SAFETY EVALUATION BY THE OFFICE OF NUCLEAR REACTOR REGULATION

FACILITY OPERATING LICENSE NO. NPF-4  
VIRGINIA ELECTRIC AND POWER COMPANY  
OLD DOMINION ELECTRIC COOPERATIVE  
NORTH ANNA POWER STATION, UNIT NO. 1  
DOCKET NO. 50-338

By letter dated September 15, 1987 (Reference 1), Virginia Electric and Power Company (the licensee) provided the document, "North Anna Unit 1 July 15, 1987 Steam Generator Tube Rupture Event Report" (Reference 2) describing its plan of action for returning the plant to full power operation. Also provided for our review was the Westinghouse Electric Corp. Report, "North Anna 1 S/G Tube Rupture and Remedial Actions Technical Evaluation" (Reference 3).

Fig. 1. Approximate Mapping of Fracture Surface of Tube B0CS1, S/G "C" Cold Leg.

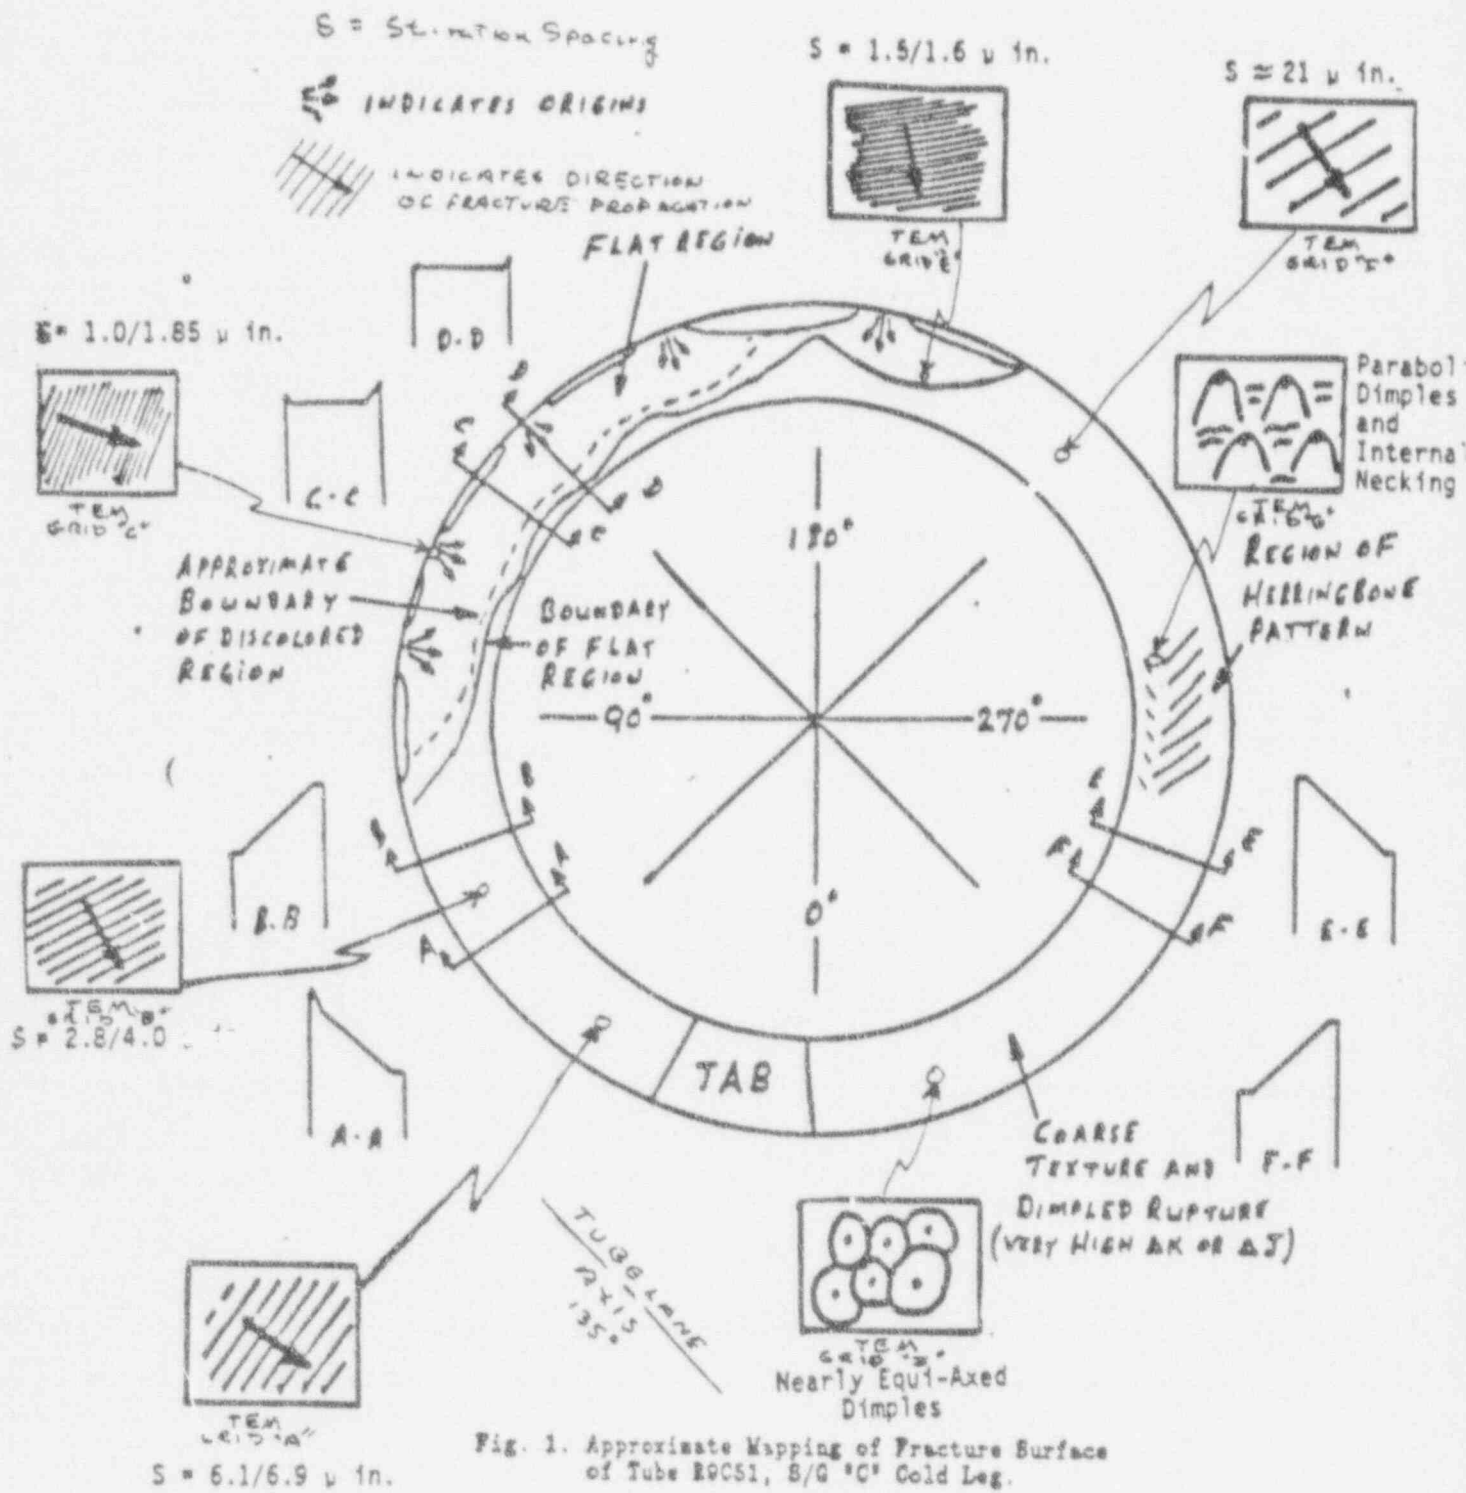
With reference to Figure 1 (taken from Reference 3), which summarizes the fractographic observations schematically, the 45° location corresponds to the plane of the U-bend. Multiple fracture initiation "origins" occurred between approximately 90° and 180°. The tubing between 90° and 180° is determined to have protruded approximately 0.07 inches above the top edge of the support plate. This location is the fracture region closest in elevation to the top edge of the support plate. The highest elevation of the fracture is located at 315° and is approximately 0.17 inches above the top edge of the support plate.

A summary of fractographic features and striation spacing measurements is presented in Table 2 and in Figure 1, which also give the estimates of cyclic stress levels that can be made from the striation spacing as described below. Replicas or "grids" of the fracture surface were examined in a transmission electron microscope (TEM). These TEM fractographic examinations were performed to provide the resolution needed to definitively determine if the striation-like markings observed during scanning electron microscope (SEM) fractography were indeed fatigue striations and to provide quantitative data pertaining to their spacing. The striations run perpendicular to the direction of local crack propagation. The striations develop as a consequence of repeated blunting and resharping of the crack tip during the cyclic applications of load, so each striation marks the position of the crack tip at the time it was formed. The striation spacing provides a rough estimate of the crack growth rate per cycle.
